CURRENT PAGES MARKED-UP TO REFLECT PROPOSED CHANGES TO THE
DONALD C. COOK NUCLEAR PLANT UNIT NOS. 1 AND 2
TECHNICAL SPECIFICATIONS

CURRENT PAGES MARKED-UP TO REFLECT PROPOSED CHANGES TO THE
DONALD C. COOK NUCLEAR PLANT UNIT NO. 1
TECHNICAL SPECIFICATIONS

Proposed Technical Specification Changes

FIGURE 2.1-1 REACTOR CORE SAFETY LIMITS

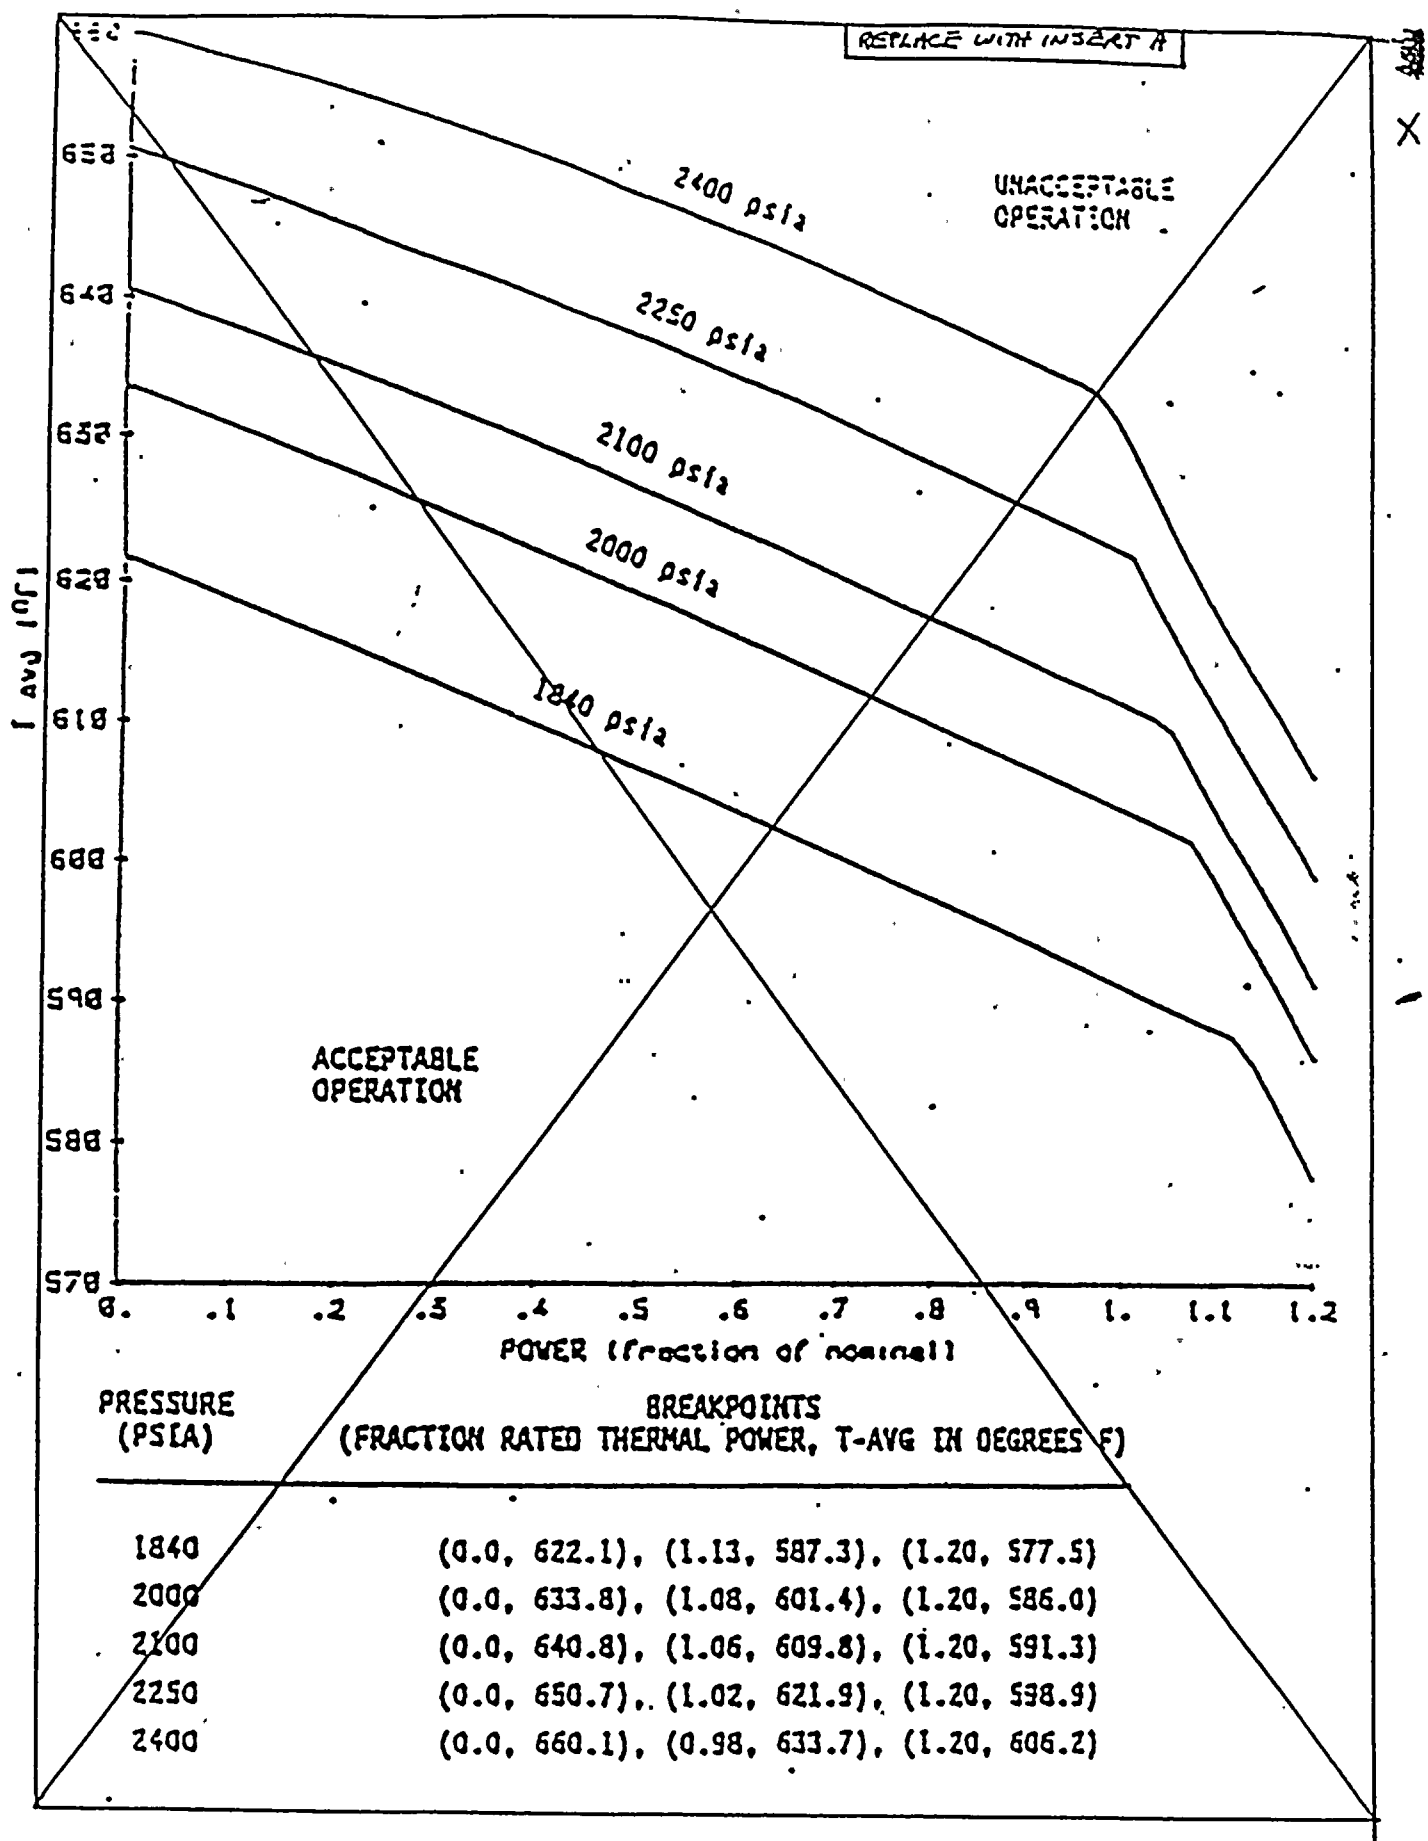
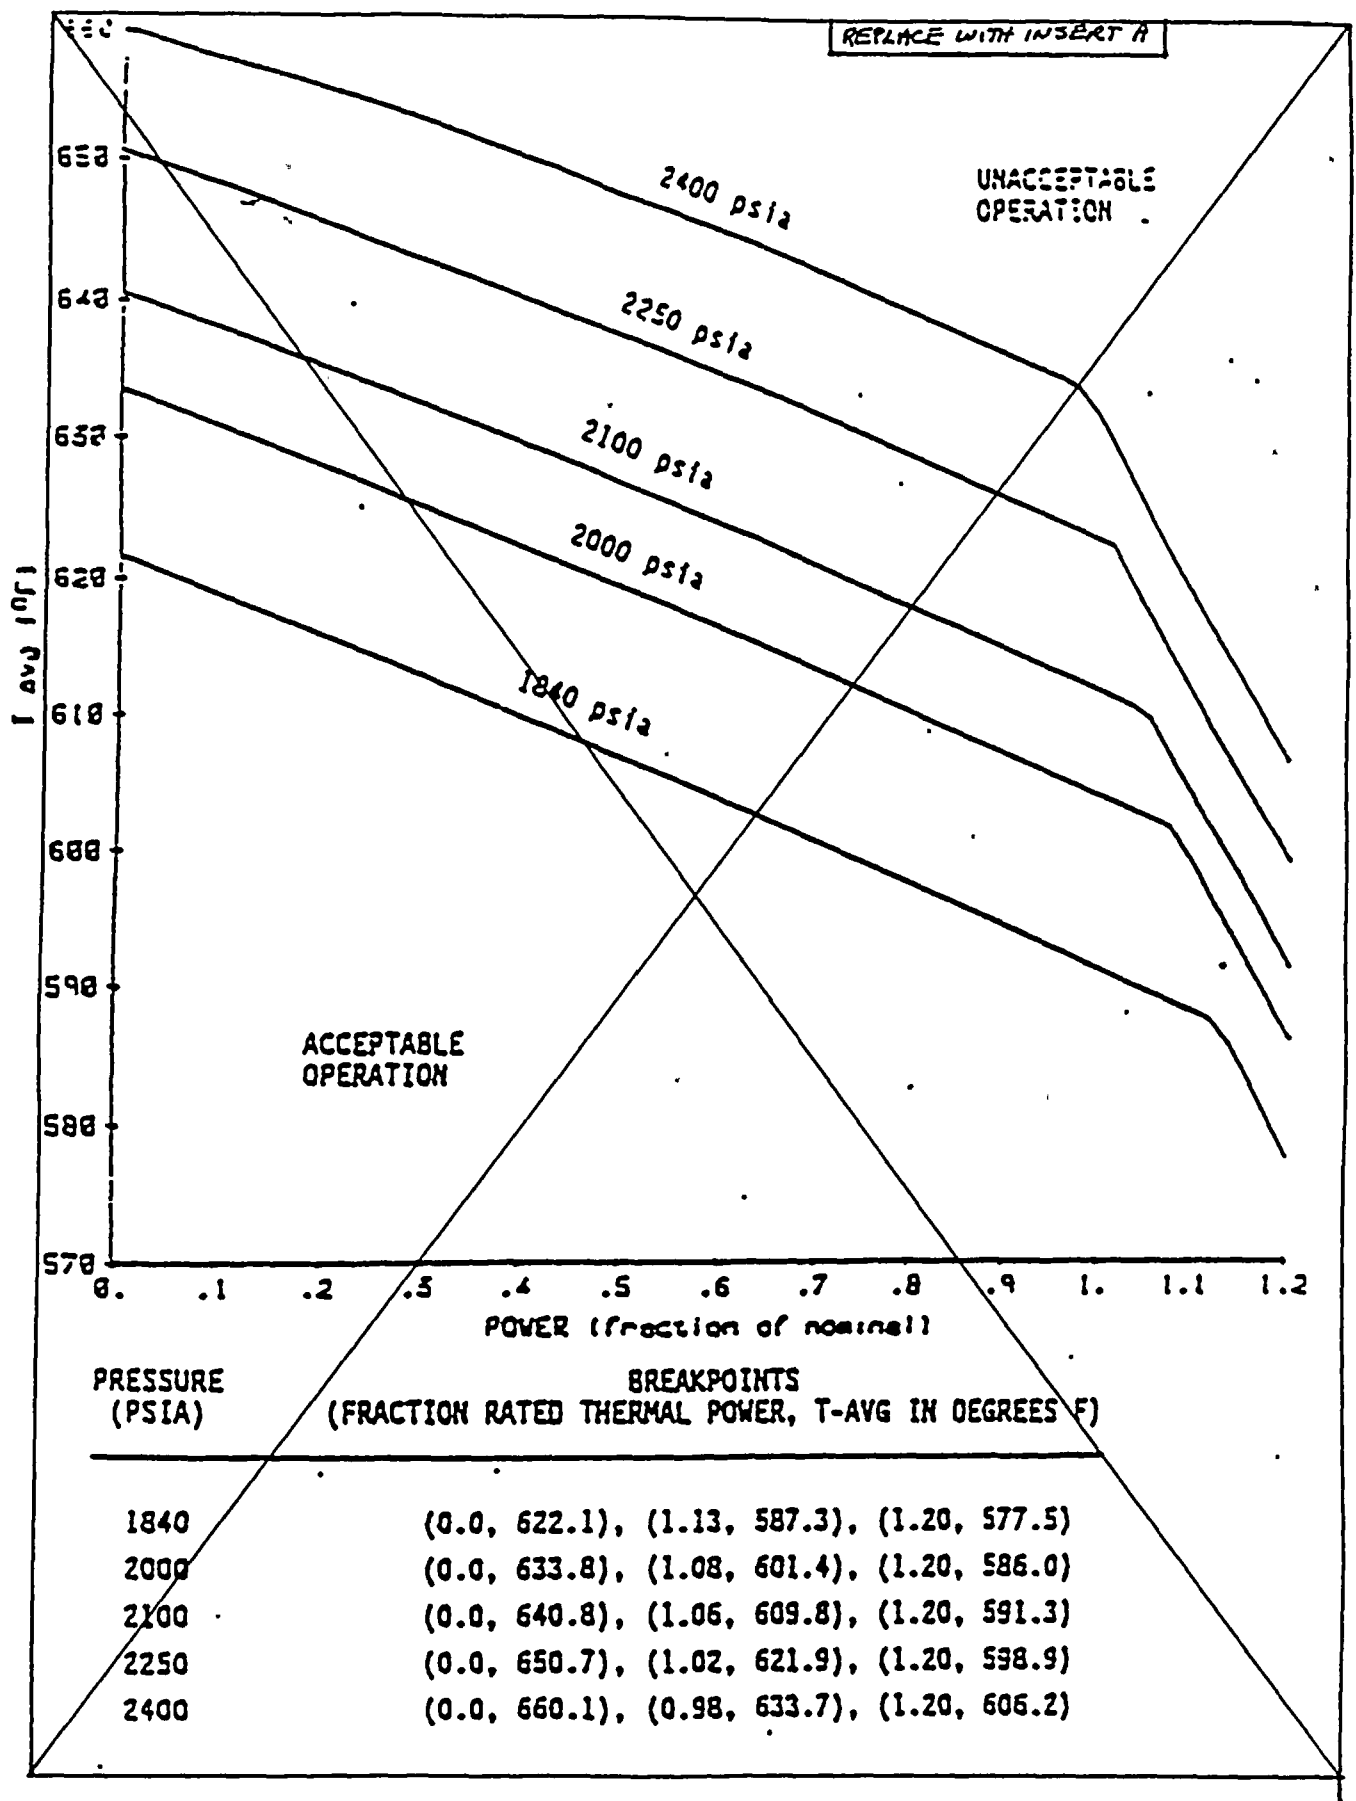
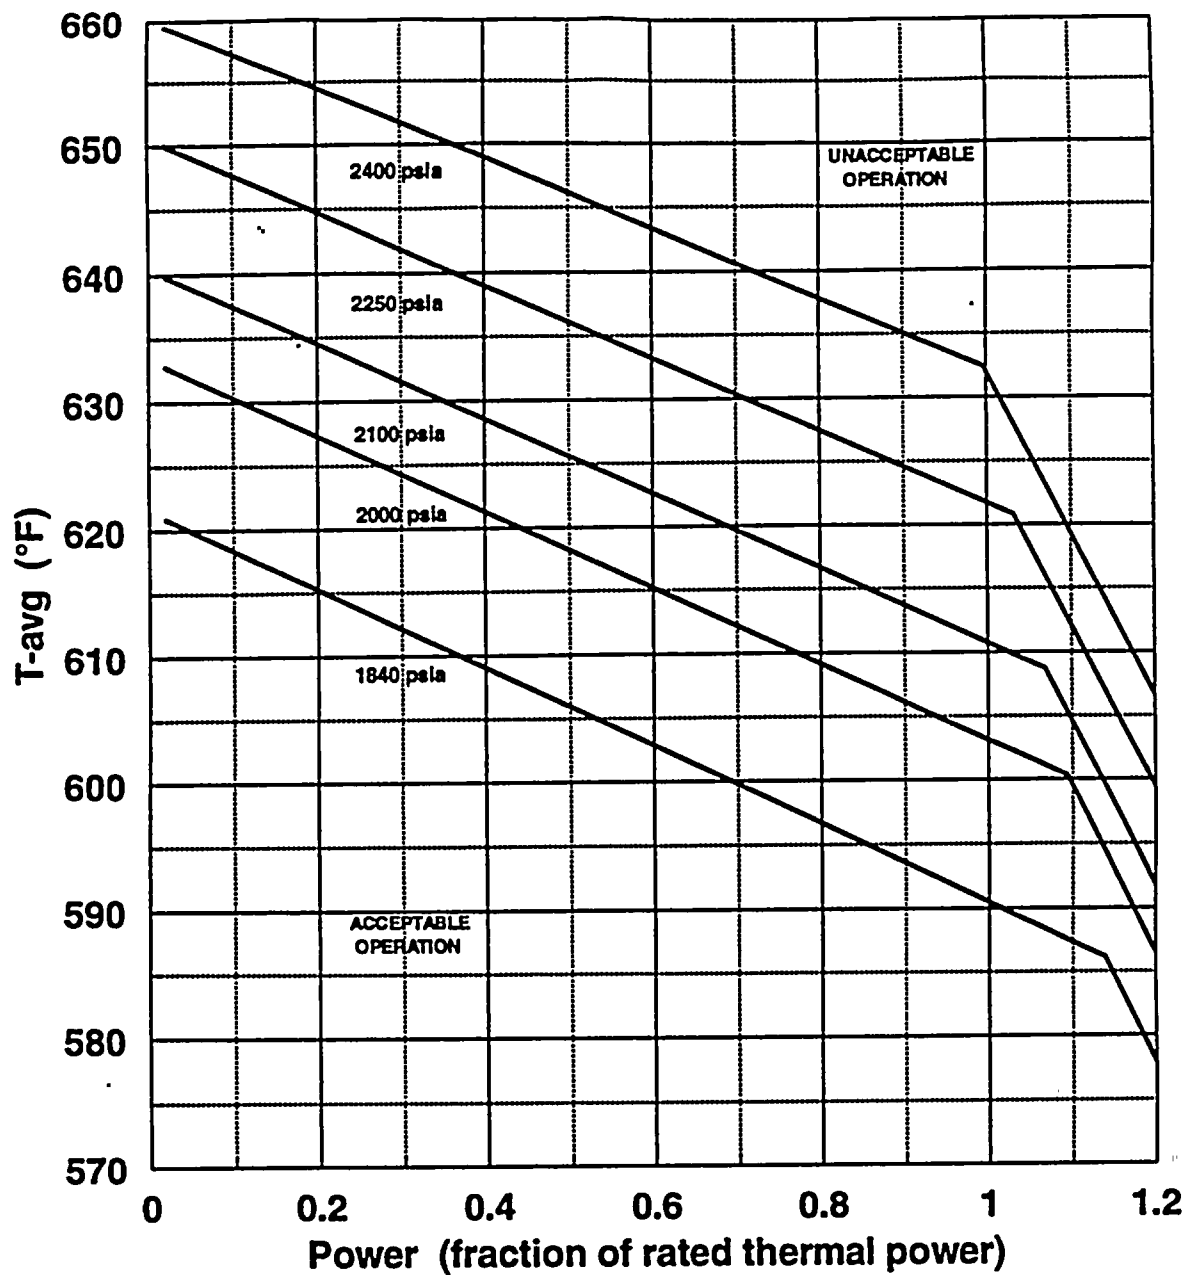
Technical Specification Figure 2.1-1, Reactor Core Safety Limits, shows the loci of points of thermal power, RCS pressure and average temperature below which the calculated DNBR is no less than the design DNBR value and the average enthalpy at the vessel exit is less than the enthalpy of saturated liquid. The figure is based on the enthalpy hot channel factor.

Figure 2.1-1 has been replaced with a new figure based on the latest analyses, reflecting 30% tube plugging, reduced rated thermal power, reduced RCS flow, etc.

<u>PAGE</u>	<u>SECTION</u>	<u>DESCRIPTION OF CHANGE</u>	<u>BASIS</u>
2-2 B 2-1(a)	2.1 Bases 2.1	Core Safety Limits Replace Figure 2.1-1, Reactor Core Safety Limits The safety analysis limit DNBR specified in the Bases for Section 2.1 has been revised from 1.45 to 1.42.	Figure 2.1-1 has been replaced with a new figure based on the latest analyses, reflecting 30% SGTP, reduced rated thermal power, reduced RCS flow, etc. Section 3.3.2.1
2-7 2-8 2-9 B 2-4 B 2-5	2.2 B 2.2.1	OTΔT & OPΔT Setpoints Revise OTΔT and OPΔT Trip Setpoint and Allowable Value notes.	Proposed settings based on new core safety limits and account for instrument uncertainties. Section 3.3.2.1 & Table 3.3-3
3/4 1-1 B 3/4 1-1	3.1.1.1	Shutdown Margin Shutdown Margin limit relaxed from 1.6 to 1.3 % Δk/k	Relaxation based on re-analysis of limiting accident - core response to steam line break. Sections 3.3.4.7 & 3.3.5.6
3/4 2-14	3.2.5 Table 3.2-1	DNB Parameters Revise Table 3.2-1, DNB Parameters, RCS T _{avg} from 570.9 °F to (581.4 -readability error) °F Readability error is responsibility of AEPSC.	T _{avg} input assumption verified by reanalyses. Sections 2.1, 3.3.2.1 & 3.12.4
